MEADOWBROOK PARK PLANNED UNIT DEVELOPMENT (PUD) PLAN

PROJECT NO. 096956009
SHEET

PUDSP Redlines V_1.pdf Markup Summary 12-15-2020

PRELIMINARY LANDSCAPE PLAN MEADOWBROOK PARK RESIDENTIAL LAYOUT

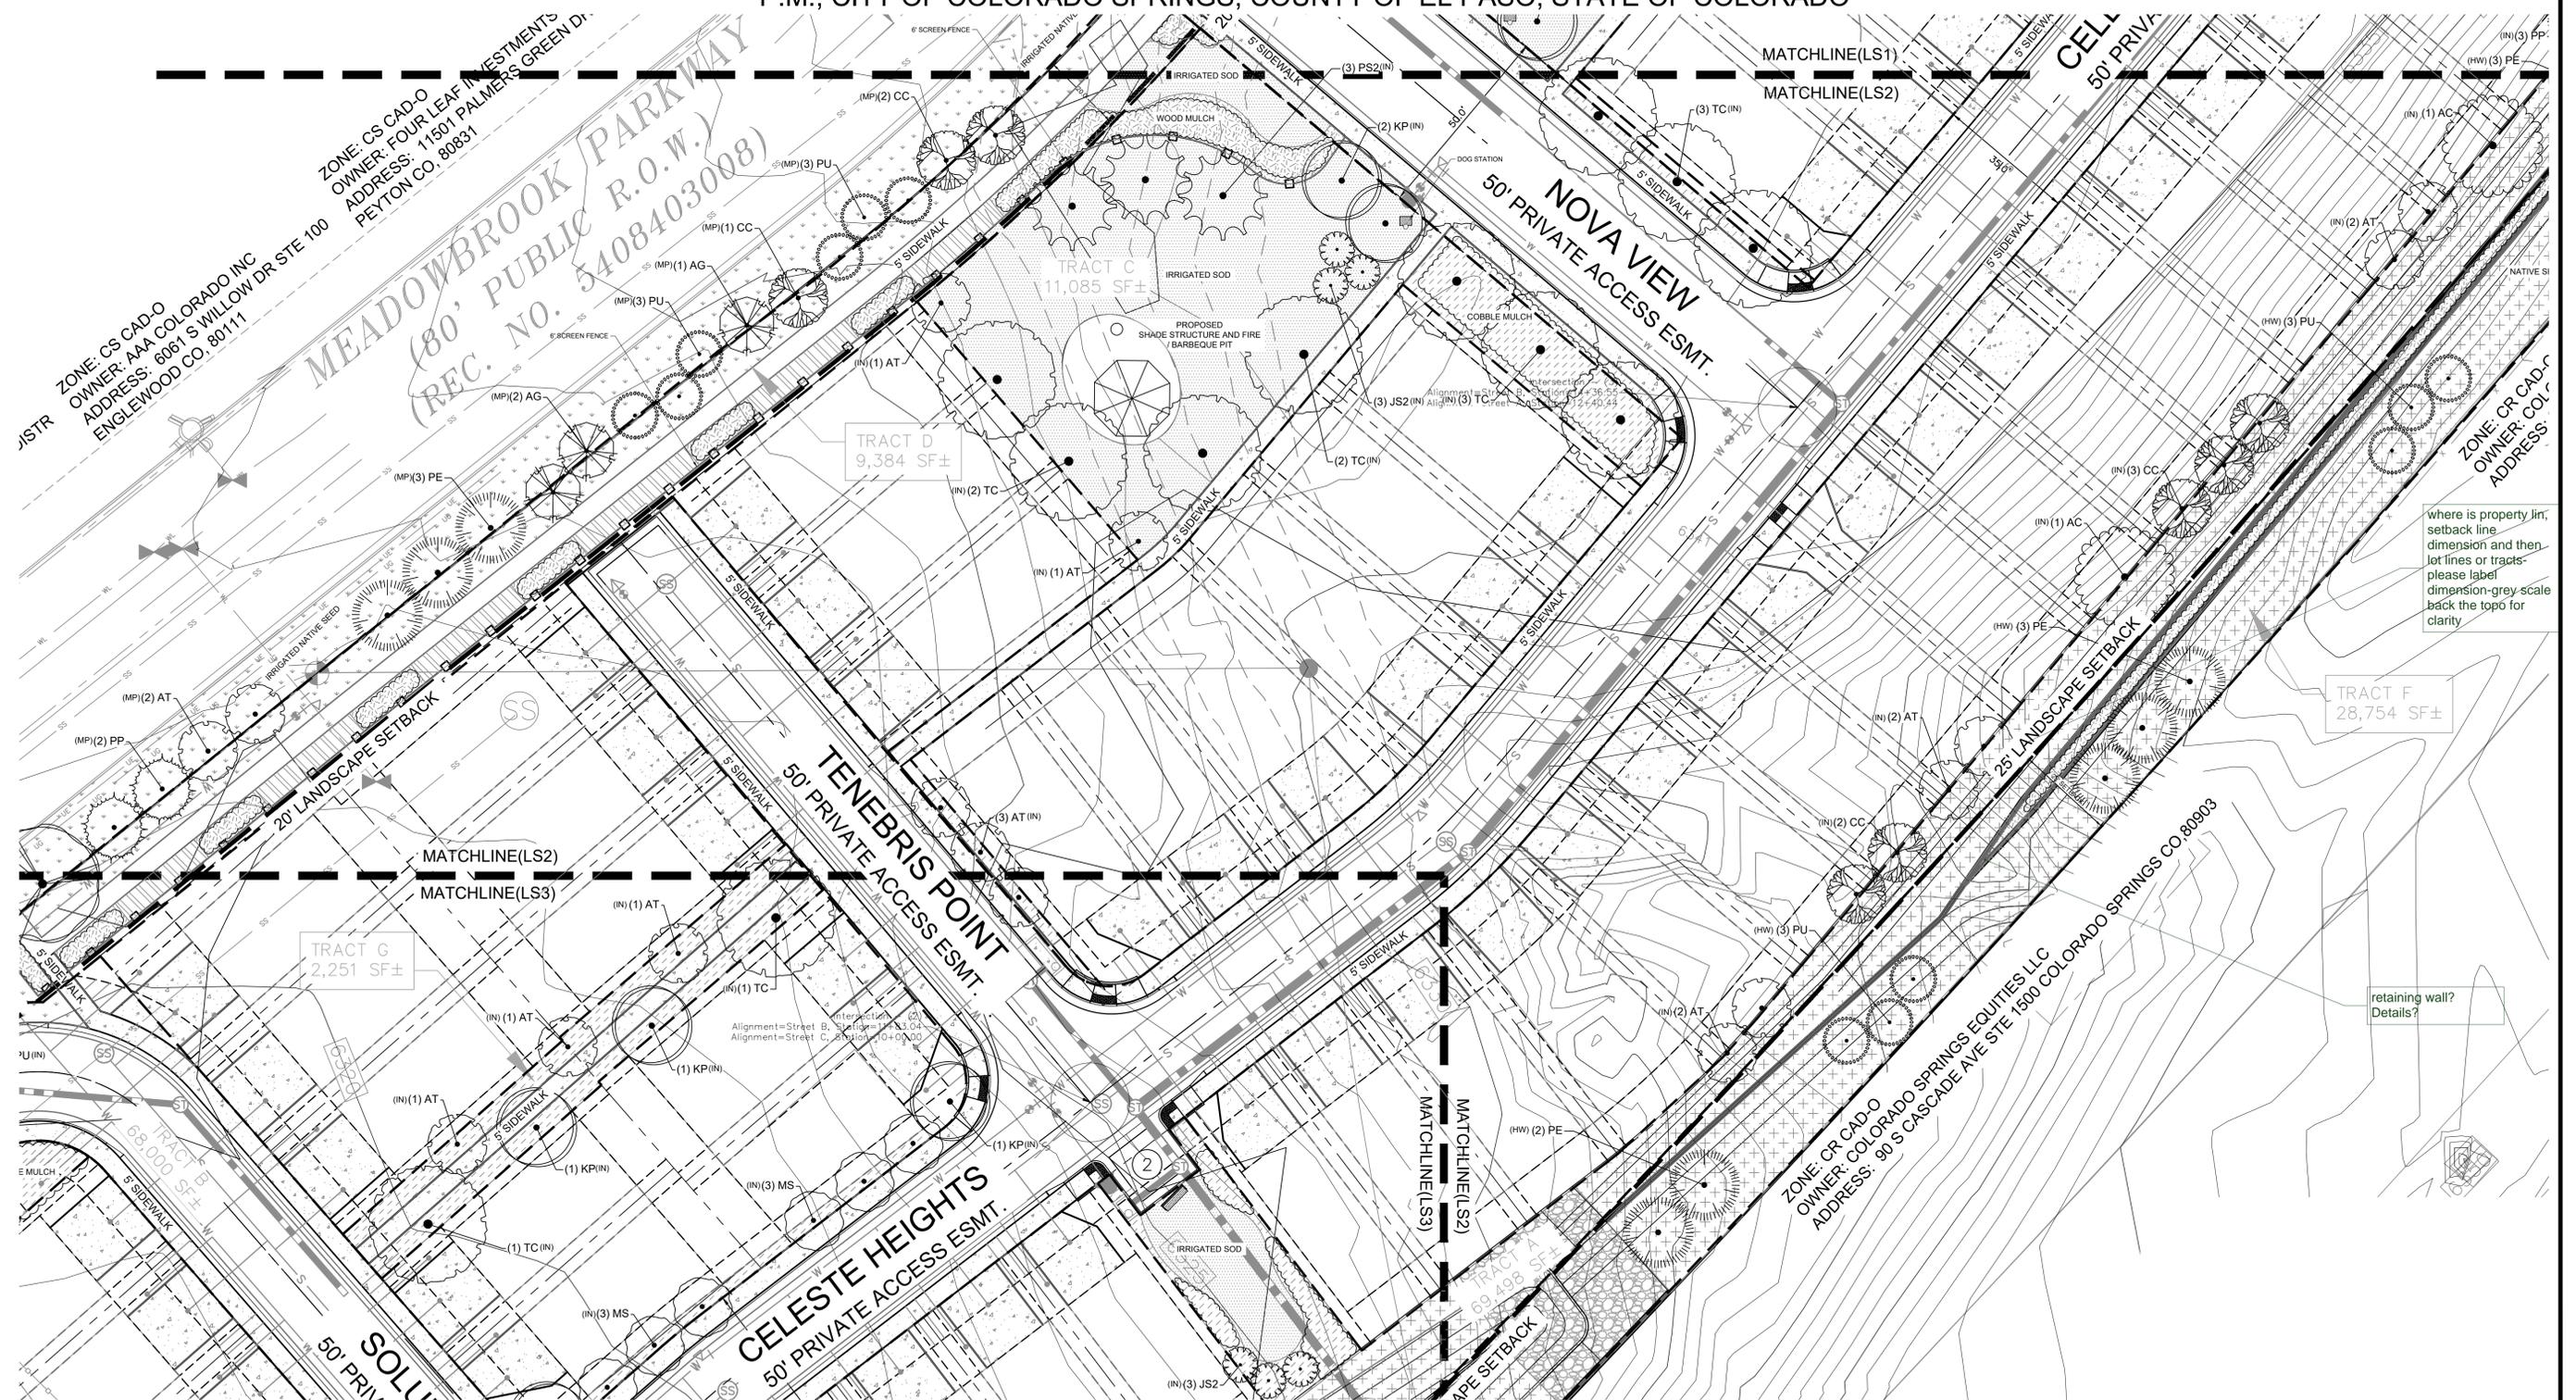
where is property line, setback line dimension and then lot lines or tracts- please label dimension-grey scale back the topo for clarity

retaining wall? Details?

PRELIMINARY LANDSCAPE PLAN MEADOWBROOK PARK RESIDENTIAL LAYOUT

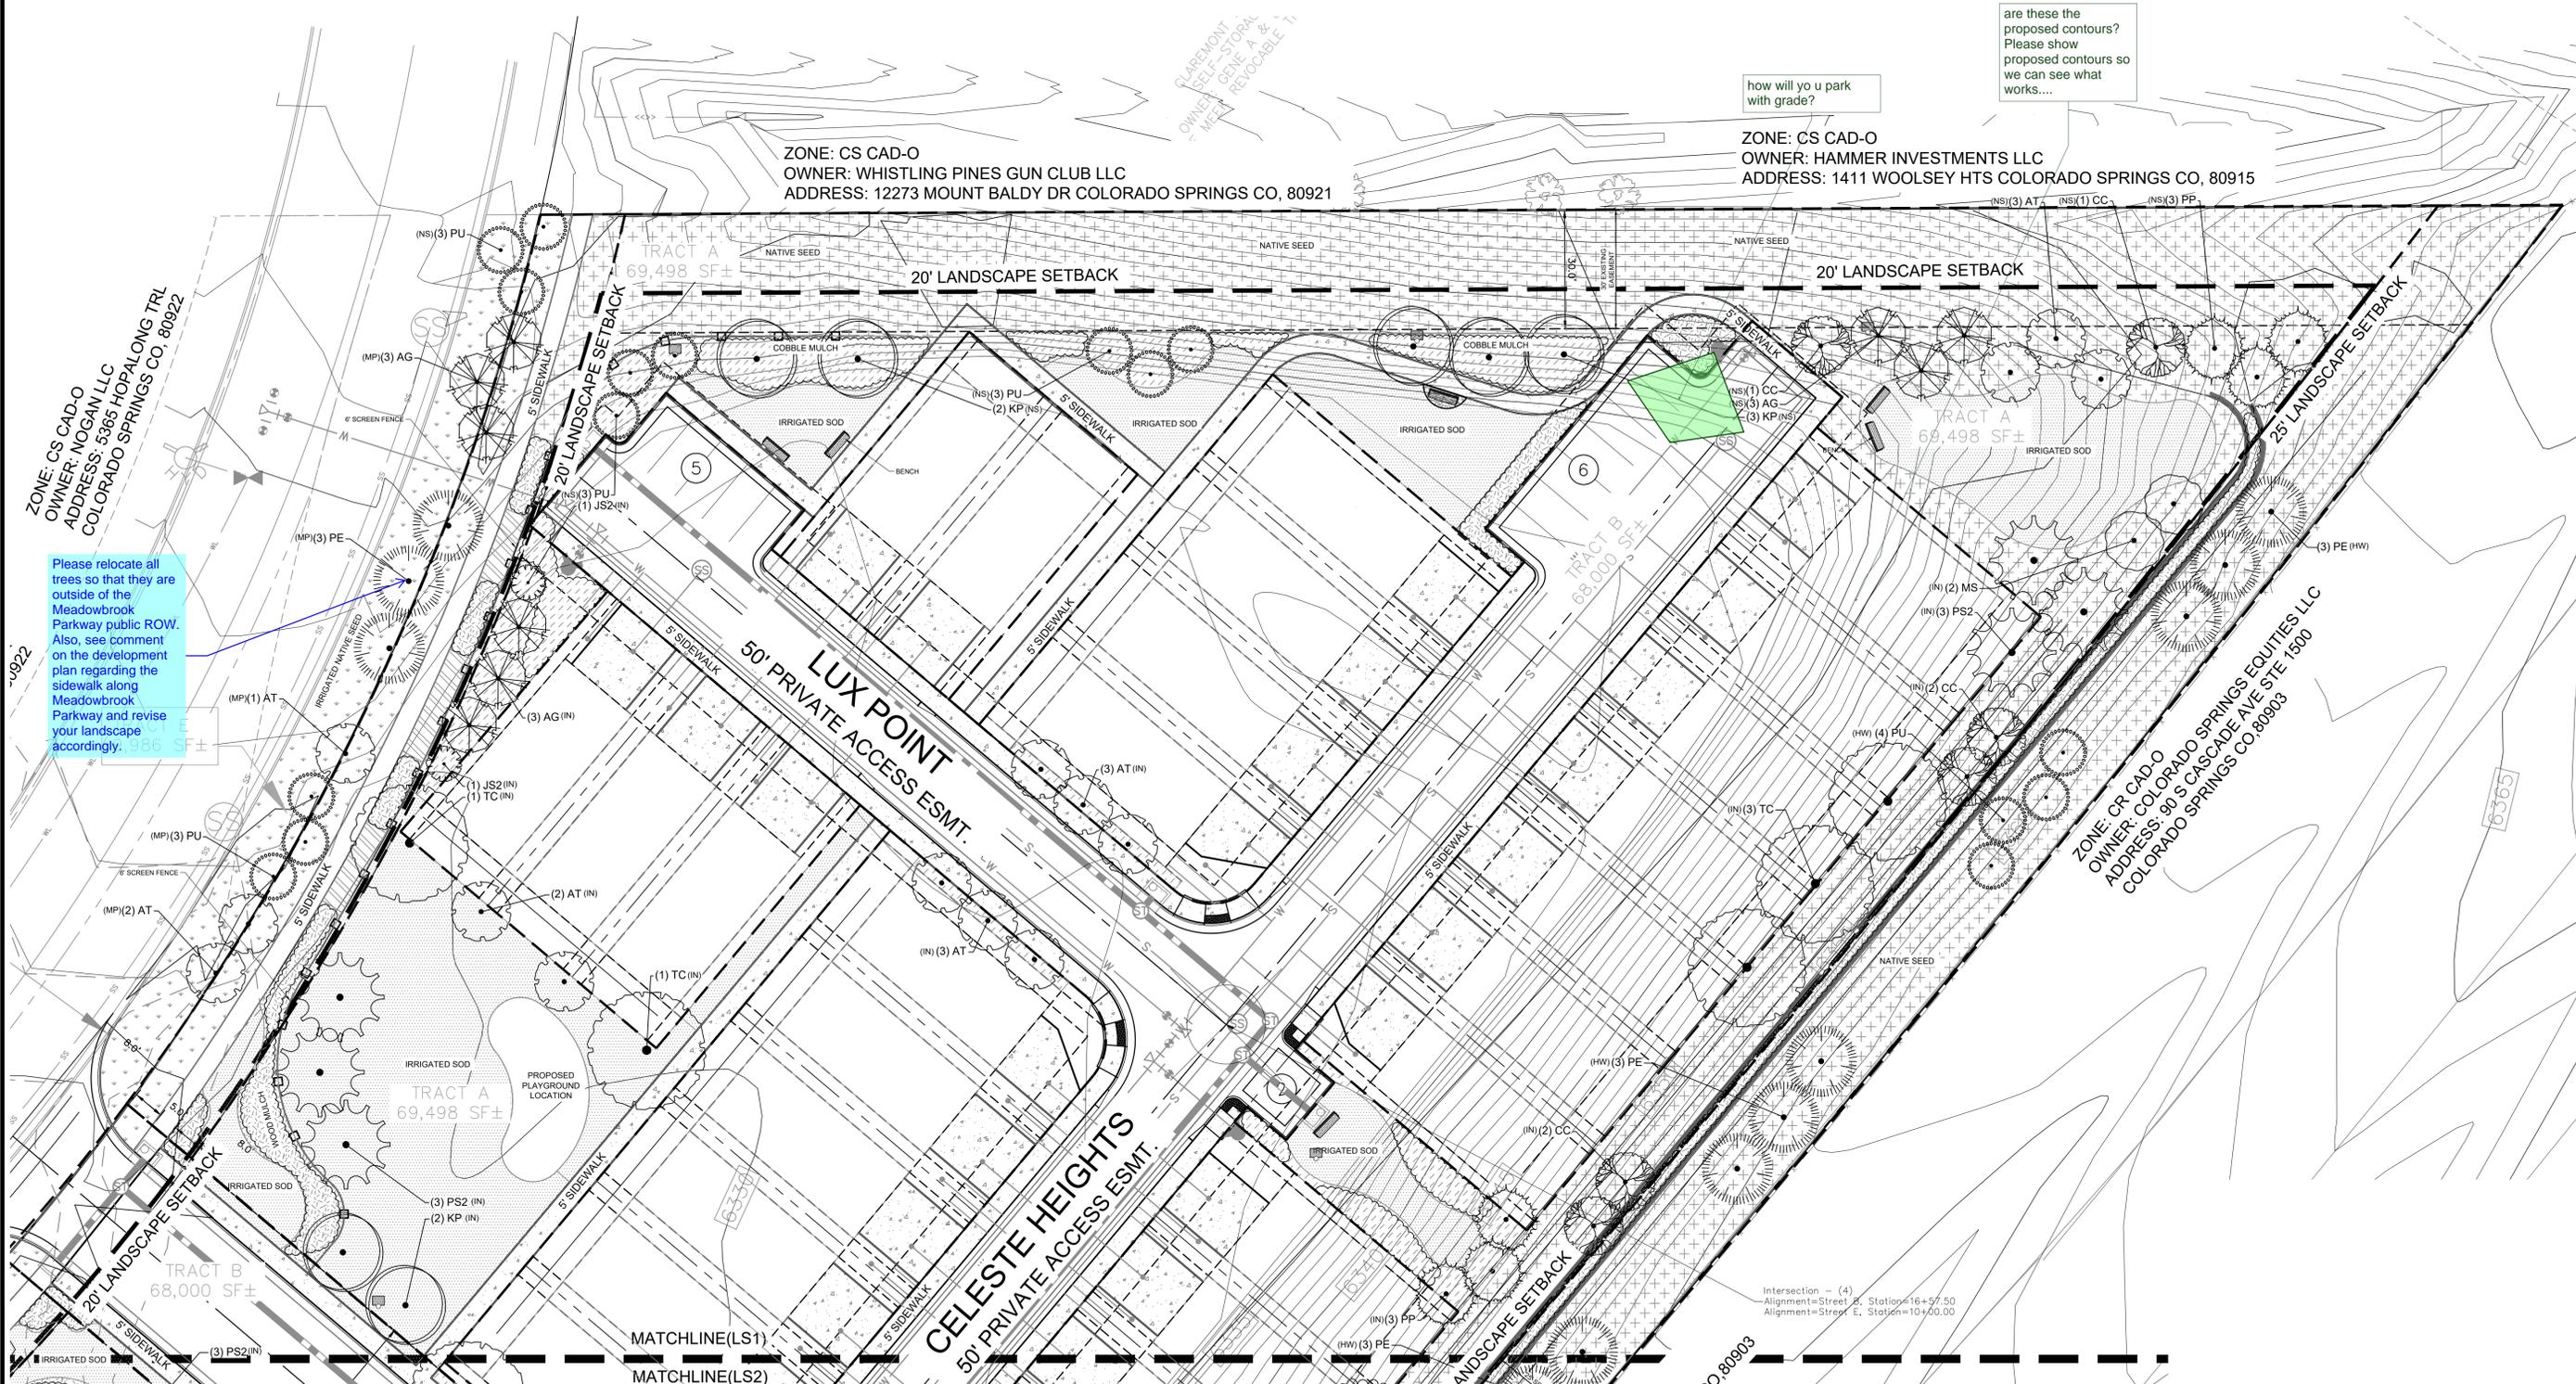
are these the proposed contours?
Please show proposed contours so we can see what works....

how will you park with grade?

Please relocate all trees so that they are outside of the Meadowbrook Parkway public ROW. Also, see comment on the development plan regarding the sidewalk along Meadowbrook Parkway and revise your landscape accordingly.
